PRODUCT ADVISORY

Data Sheet Specification Correction for the Listed Intersil EPSOIC Packaged Products

**Refer to:
PA12030**

M8.15B

Incorrect POD – PA12030

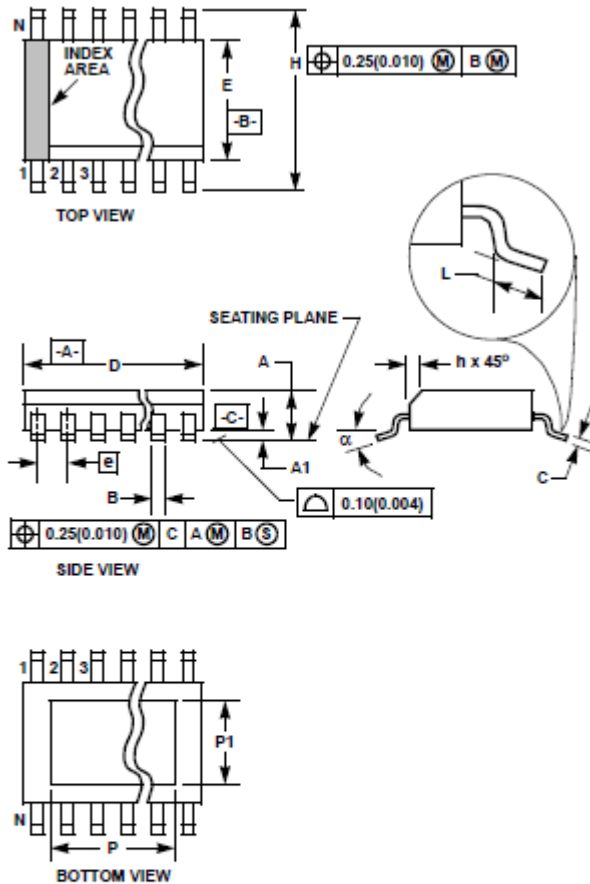
This advisory is to inform you that Intersil has made corrections to the POD (Package Outline Drawing) referenced in the data sheet specifications for the listed EPSOIC (Exposed Pad Small Outline Integrated Circuit) packaged products. The updates to the POD correct the package body width ("E") millimeter minimum and maximum dimensions, terminal length for soldering ("L") millimeter maximum dimension, and change the controlling dimension from millimeter to inches in Note 10. There have been no changes made to the package or product itself. The updated data sheets incorporating the corrected POD are available on the Intersil web site at <http://www.intersil.com/data/fn/fn9072.pdf>, <http://www.intersil.com/data/fn/fn9159.pdf>, and <http://www.intersil.com/data/fn/fn9205.pdf>.

SYMBOL	INCHES		MILLIMETERS		NOTES
	MIN	MAX	MIN	MAX	
A	0.056	0.068	1.43	1.68	-
A1	0.001	0.005	0.03	0.13	-
B	0.0138	0.0192	0.35	0.49	9
C	0.0075	0.0098	0.19	0.25	-
D	0.189	0.196	4.80	4.98	3
E	0.150	0.157	3.31	3.39	4
e	0.050 BSC		1.27 BSC		-
H	0.230	0.244	5.84	6.20	-
h	0.010	0.016	0.25	0.41	5
L	0.016	0.035	0.41	0.64	6
N	8		8		7
α	0°	8°	0°	8°	-
P	-	0.094	-	2.387	11
P1	-	0.094	-	2.387	11
